ADDRESS: 1221 PINE ST

Proposal: Replace bays; install roof deck, window in doorway, and basement stairs

Review: Final Review Owner: 1221 Pine 1 LLC

On Tuesday October 28<sup>th</sup>, VMA presented proposed exterior renovations to the Architectural Committee. In response to the committee's review, we have adjusted our proposal and have included those in the attached presentation.

#### **WEST ELEVATION - UPDATES**

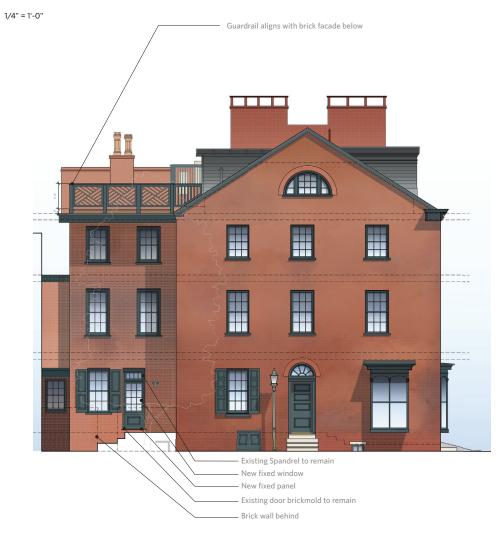
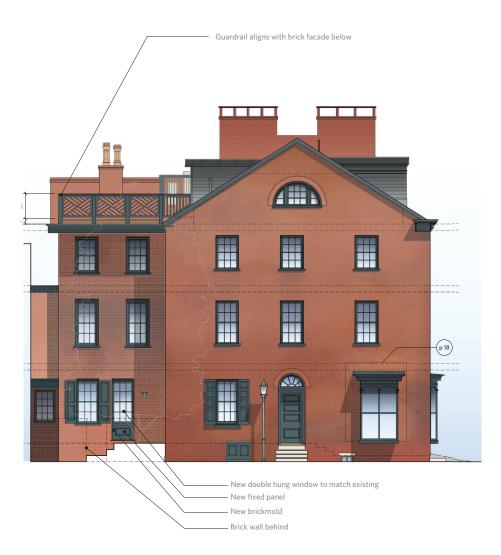
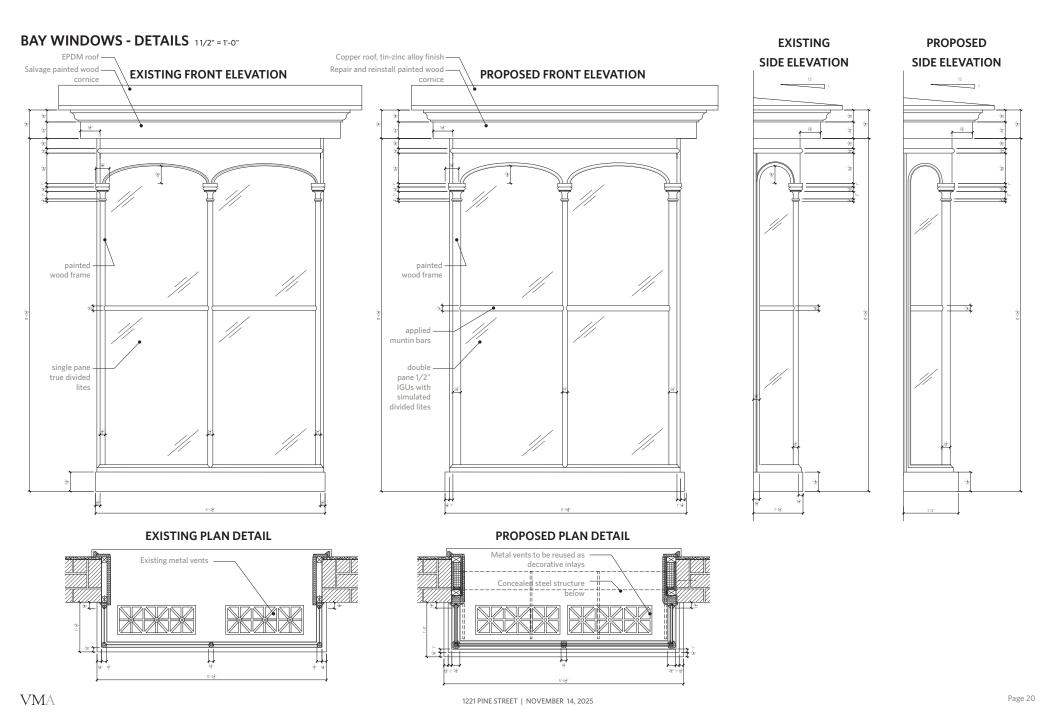
- We originally proposed removing the existing door and transom along the Camac Street West Elevation and replacing it with a new window to align with the windows above. This proposal is shown on sheet 18. The Architectural Committee asked that we keep the door's masonry opening and the transom and replace the door sash with glass, so that a new masonry opening was not cut into the façade. We have shown that option on sheet 19.

- We have also shown a third option for consideration on sheet 19, adjacent to the Committee's requested proposal. In this proposal we keep the doors masonry opening, remove the transom, and insert a new window to align with the window to the left.

- We would request the Commission's approval of our original proposal on sheet 18. If the Commission is in favor of keeping the masonry opening of the original door, we would request removal of the transom and infill with the window to align with the adjacent window, the option on sheet 19.

KEEP MASONRY OPENING, BRICKMOLD, AND TRANSOM. REMOVE DOOR.

KEEP MASONRY OPENING. REMOVE DOOR, BRICKMOLD, AND TRANSOM.

# PROPOSED ROOF DECK WEST ELEVATION - UPDATES

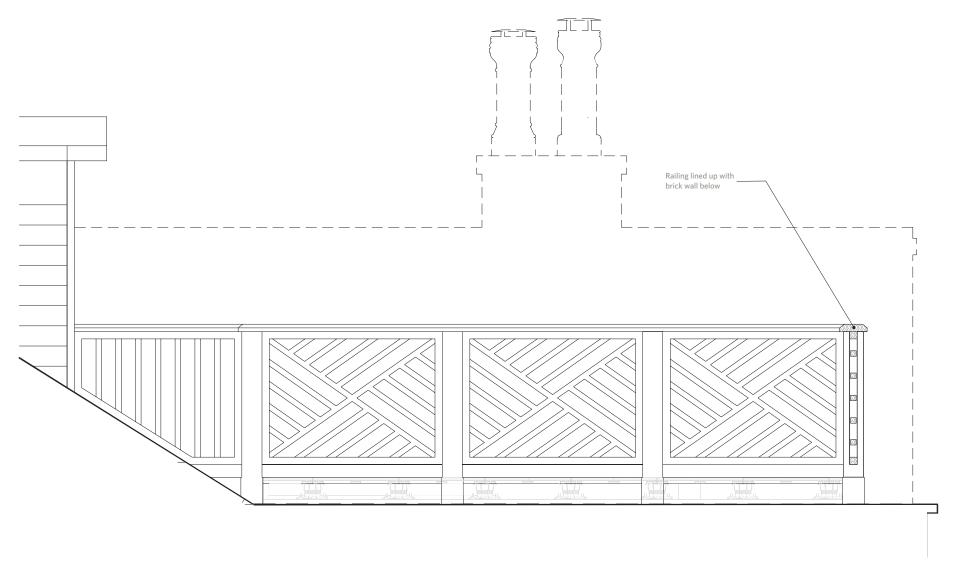
• The Architectural Committee asked that the new deck railing be brought inboard, such that it aligns with the face of the exterior façade. We have revised the railing, and it is shown on sheets 17 and 19.

RESPONSE TO ARCHITECTURAL COMMITTEE MEETING COMMENTS
